**ZONING BOARD OF ADJUSTMENT
P.O. BOX 227
FREEDOM, NH 03836**

Freedom Zoning Board of Adjustment: **October 26, 2021**

Chairman Lees invited Application # **26-4-21 Eugene W. & Denise Lawnicki**. *Continued from September 28, 2021.*

Submittal to the Freedom Zoning Board of Adjustment Regarding Case 26-4-21, Eugene W. and Denise M. Lawnicki, October 26, 2021 meeting

Primary view shed

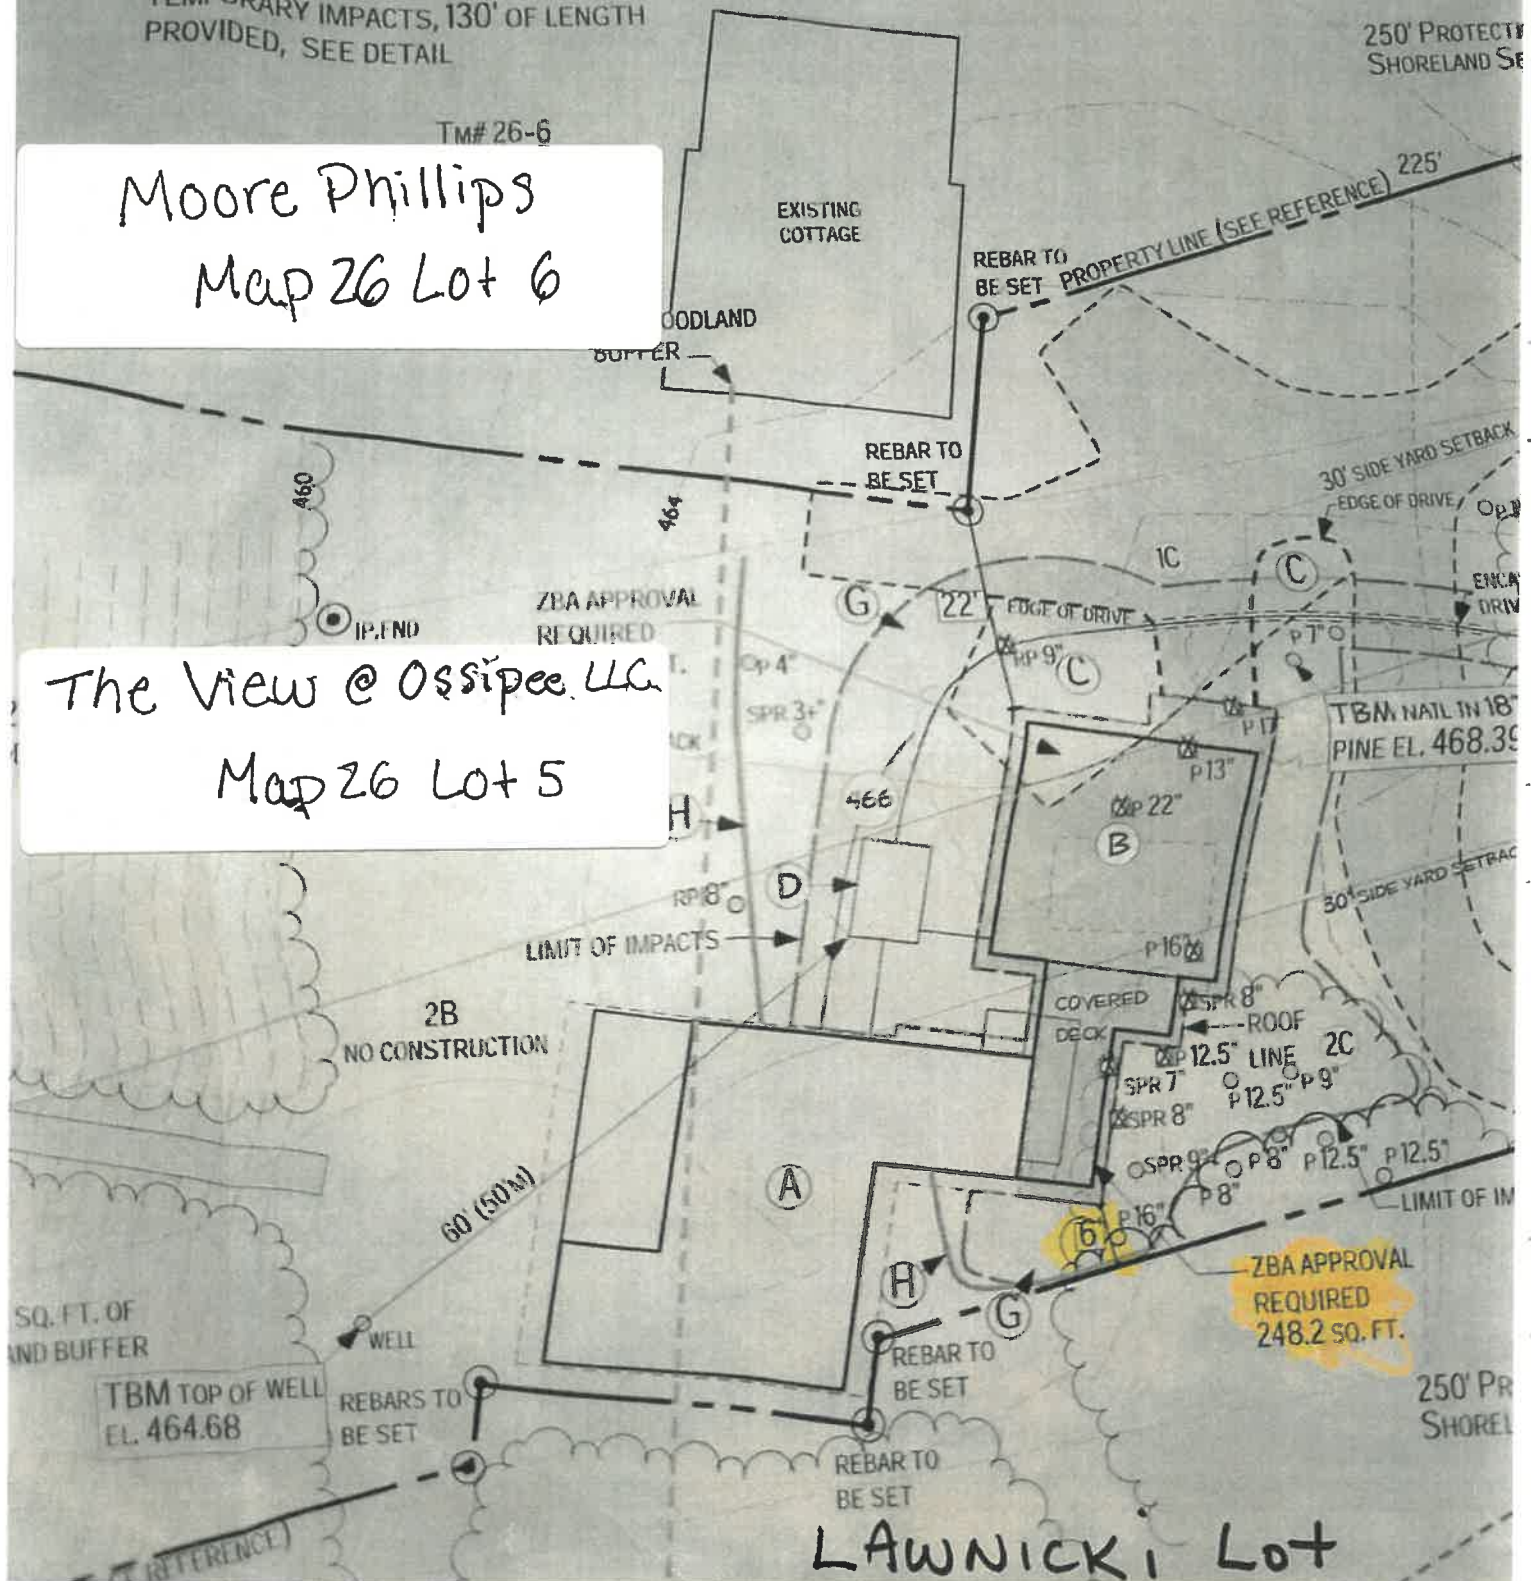
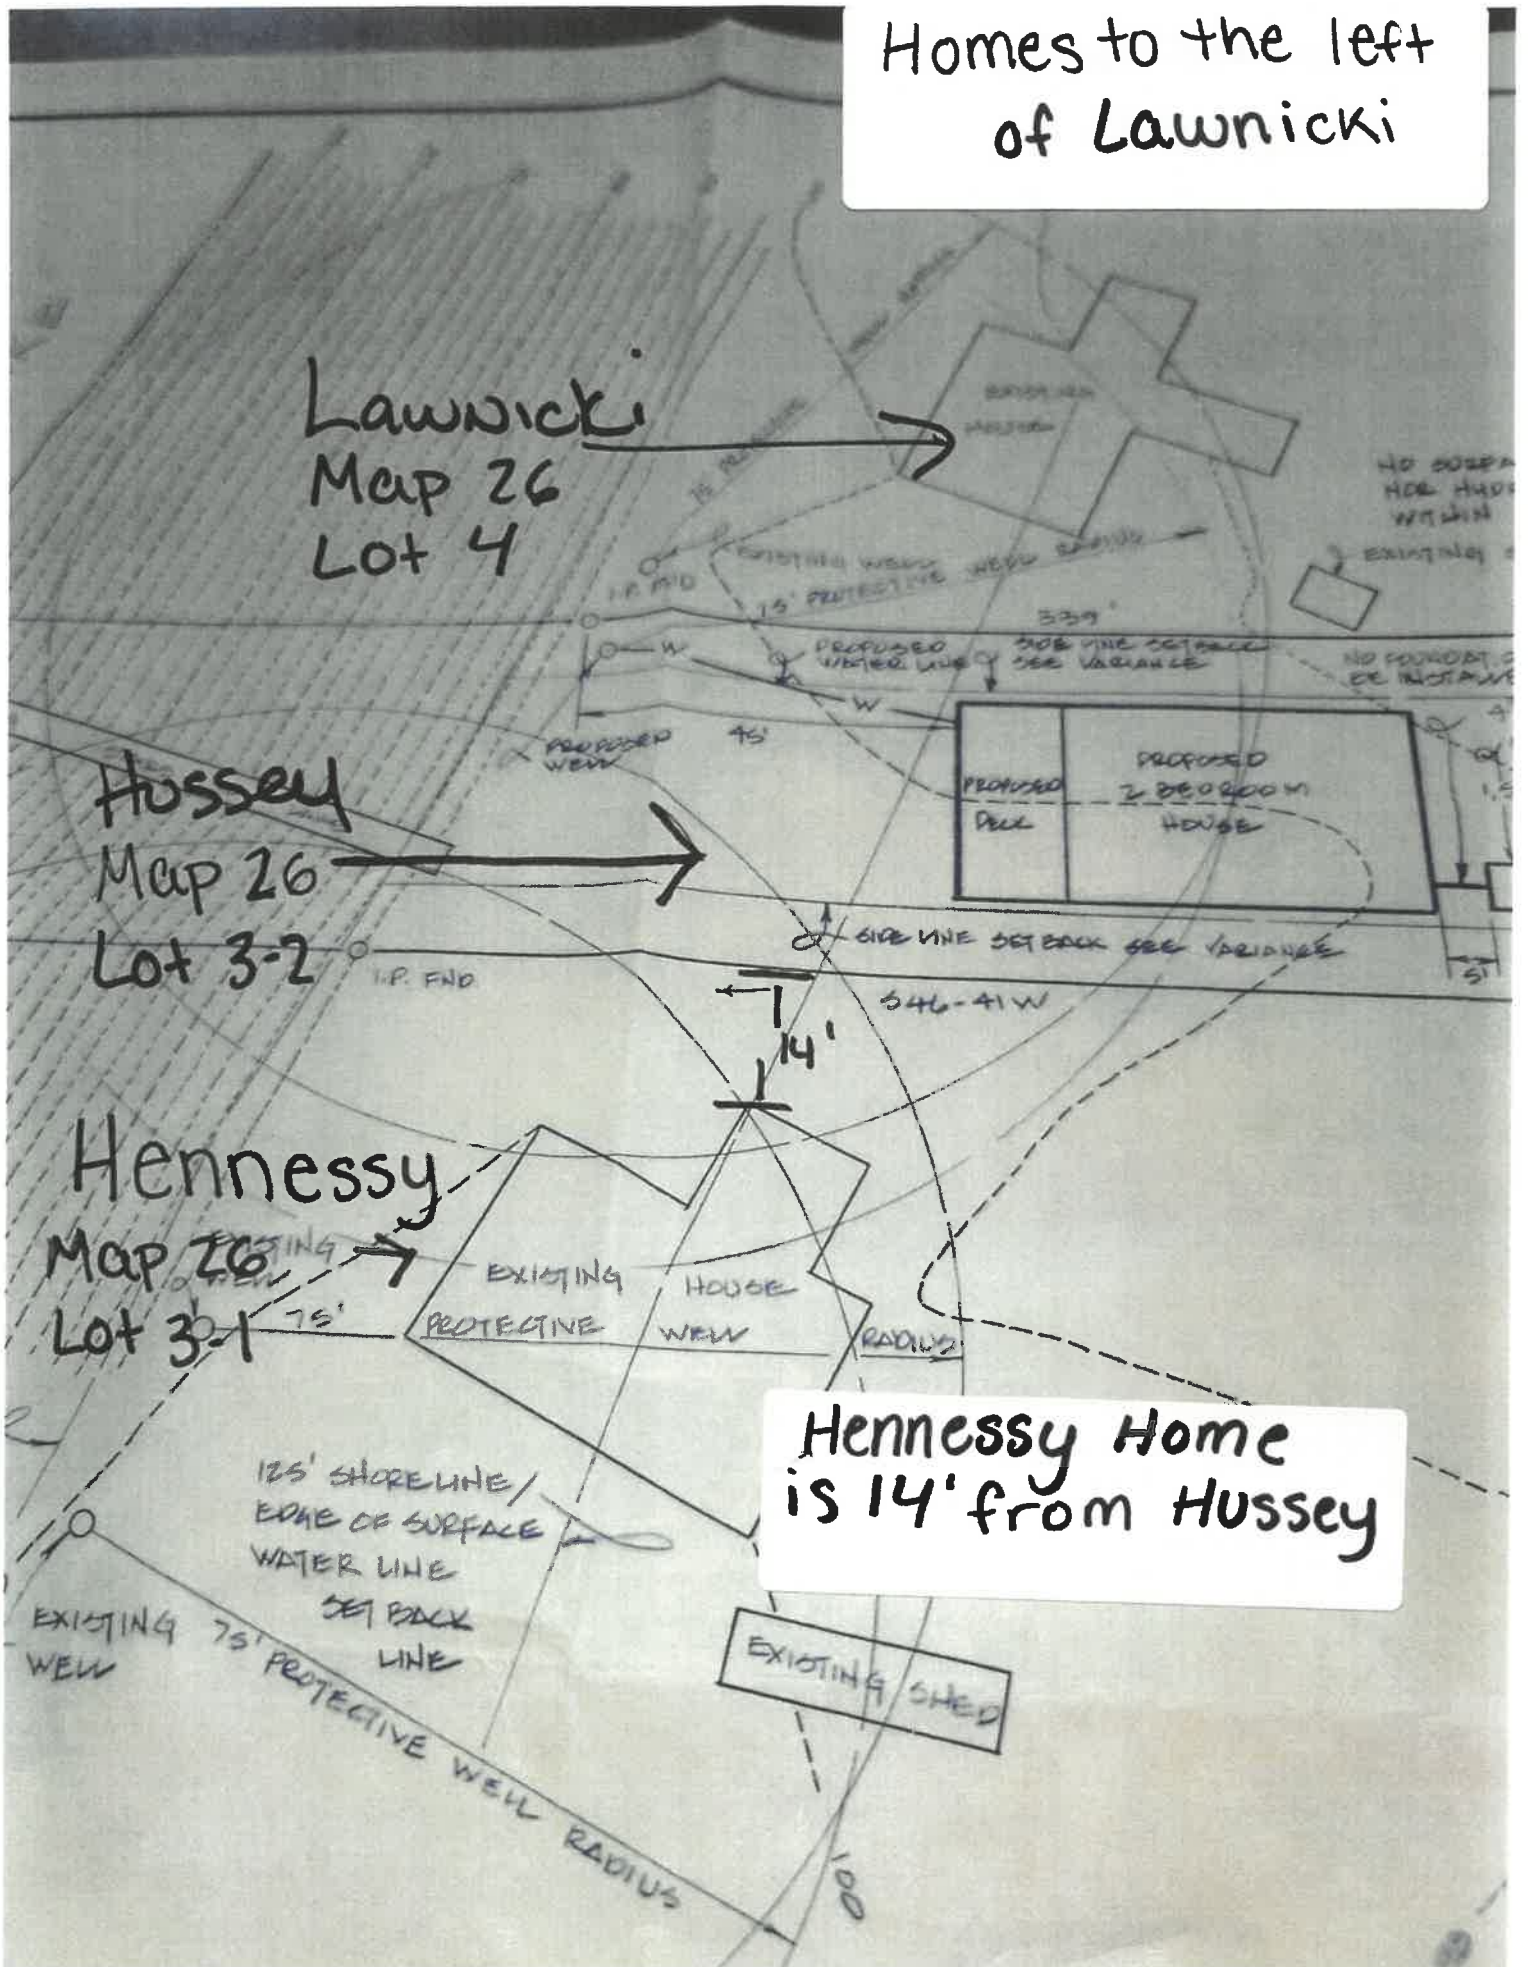
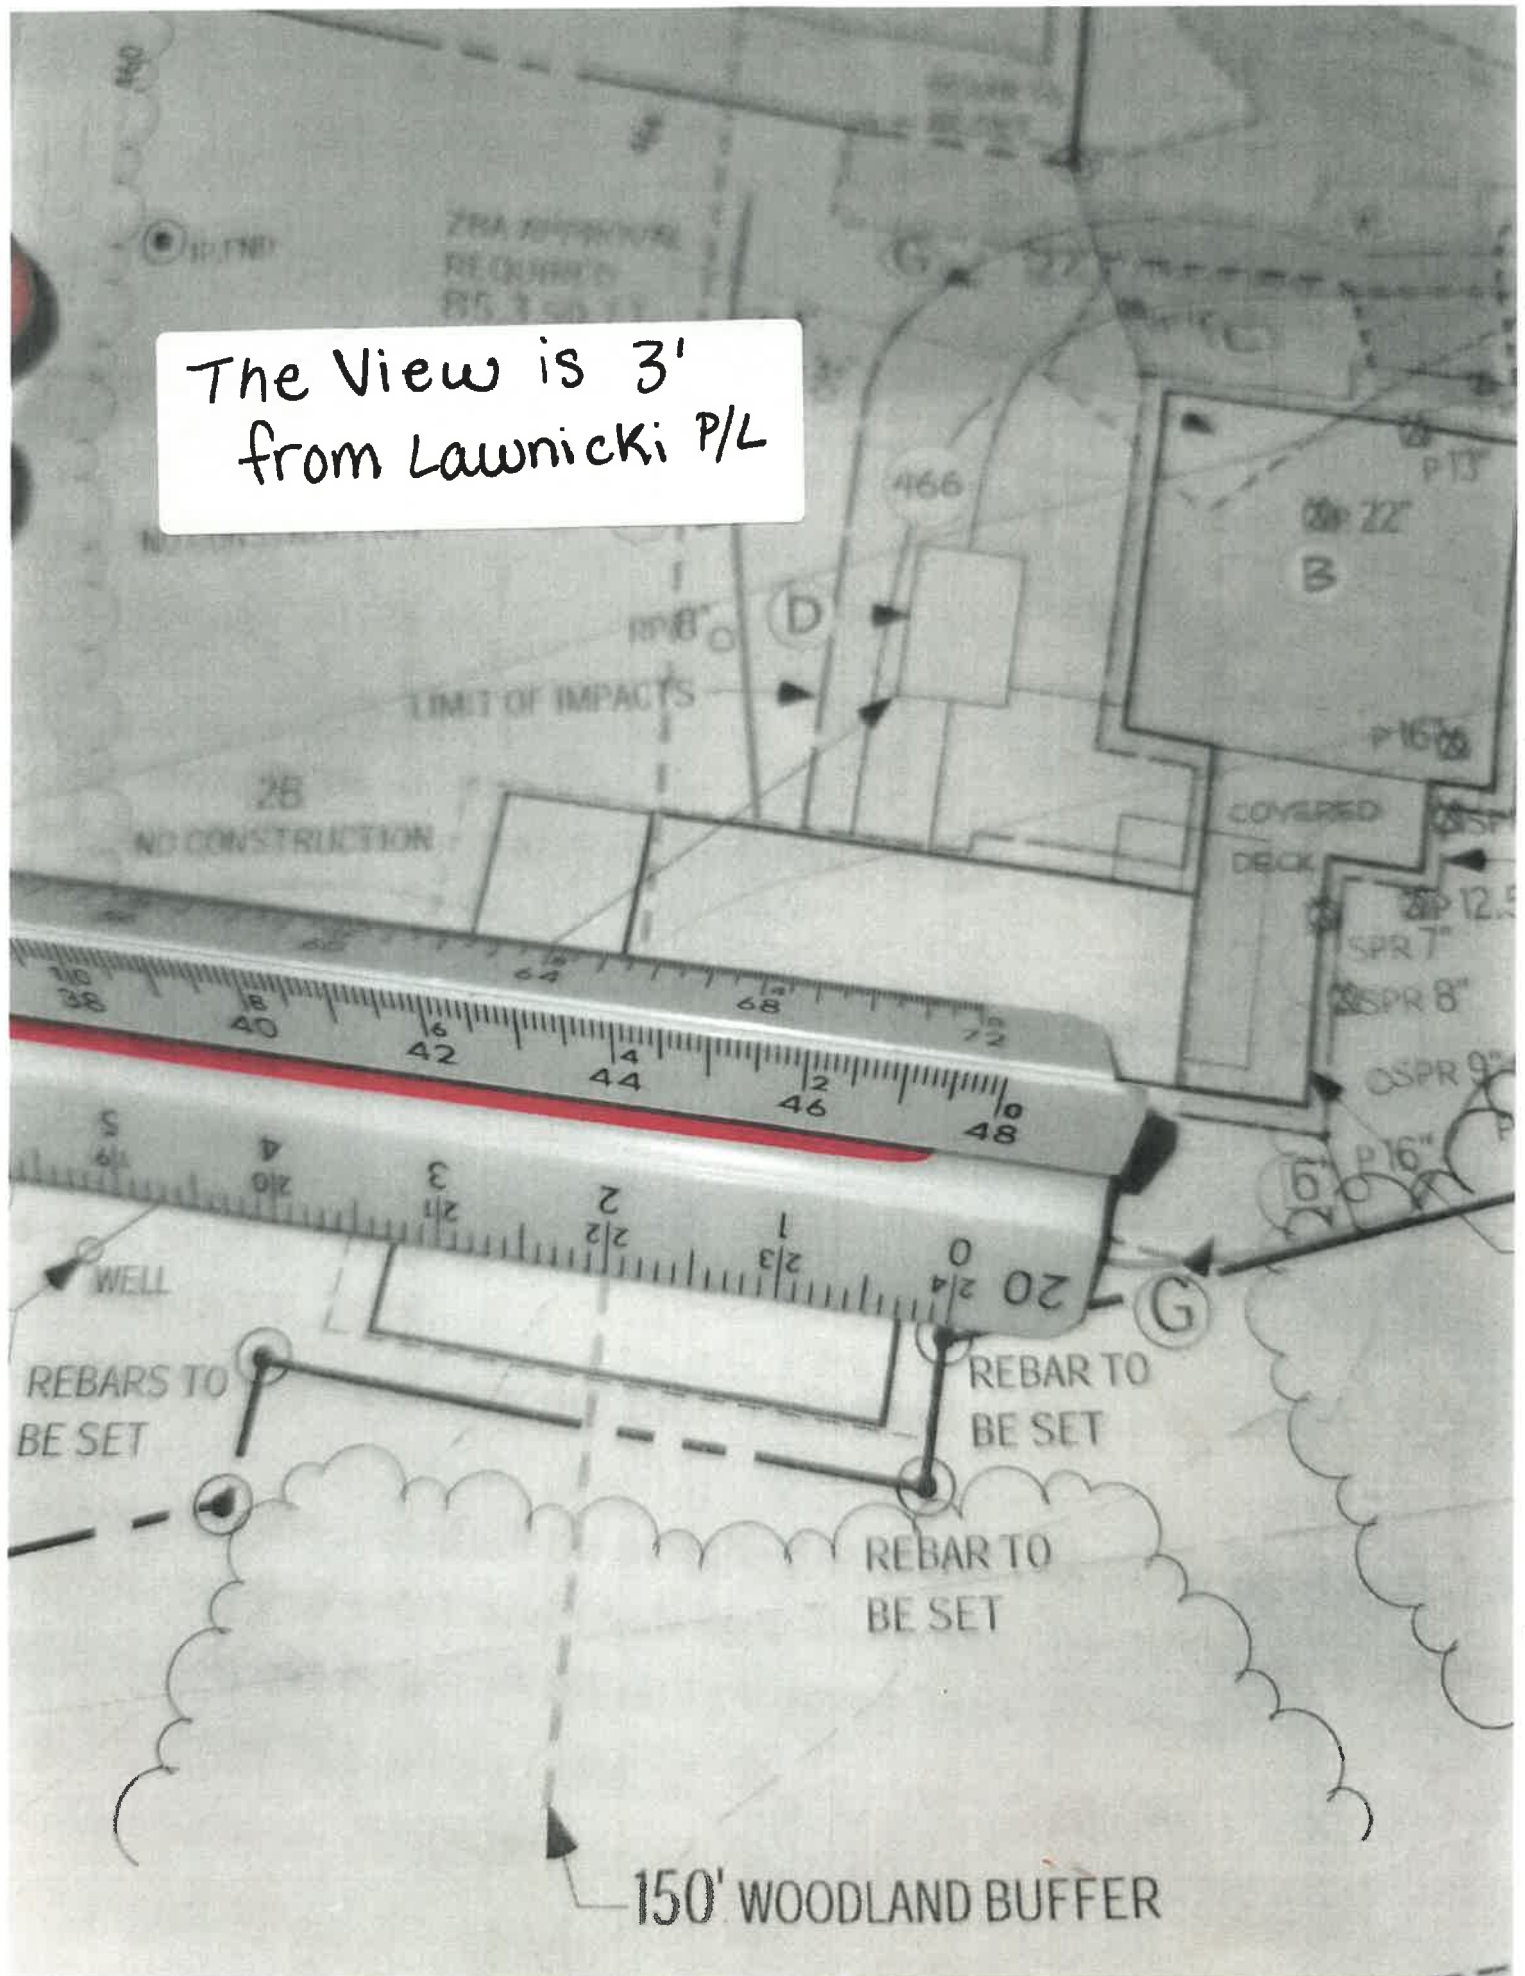
Mark reviewed the handout Primary Viewshed and explained a primary view and homes in the neighborhood located in close proximity to the Lawnicki's property line. The average offset from the neighbors' homes to the Lawnicki's property line is 8.75'. The Lawnicki's home offset to the View property line is 30.93' and to the Hussey property line is 14.91'. Mark stated the Lawnicki's are less non-conforming than the neighbors and suggests that if we go two sides on either side, that is a good betrayal of this neighborhood. Mark continued to review the Viewshed handout which included details around the width of the pathway and the architectural site plan. The proposed additions to the home all meet zoning setbacks. Mark explained the Lawnicki's are not asking for a variance for the porch in front of the garage and breezeway.

Krebs questioned the 20" tree in grid 6 next to the septic system marked for removal and how the 20" pine on the edge of the proposed driveway will survive the construction. He also questioned why the septic tank can't be moved closer to the house to save the 20" pine that they are asking a variance for and move the driveway closer to the Pequawket side to save the 20" tree on the edge of the proposed driveway. Karl stated grid six does not make sense to him because the points don't add up. A brief discussion ensued around grid six. Mark responded to John's question about the driveway and explained he doesn't see that they are putting in a gravel driveway that would need excavation. They were tasked with making sure they had ample room for turnaround which he believes there now is and they will come back if they need to. John responded he is only suggesting moving the turnaround 5' toward Pequawket Trail to avoid 20" pine on the edge of the proposed driveway and help them with the turnaround and maybe a variance would not be needed.

- Grid 2 tree counts are wrong.
- Grid 6 tree counts are wrong.
- The changing room is too big. Whatever the size of the bathhouse was originally is the size going forward. remove the label *bathhouse* on all plans.
- There is a bulkhead on the architectural plan that is not on the proposed plan.
- They are asking for a sideline setback for the house and changing room. May not need a setback for the changing room.
- Paul King stamp the plan.
- Make sure the tree species are correct on the tree cutting plan.
- Existing well labeled.
- Move the septic tank to save the pine.
- Move the driveway to save the other 20" pine.
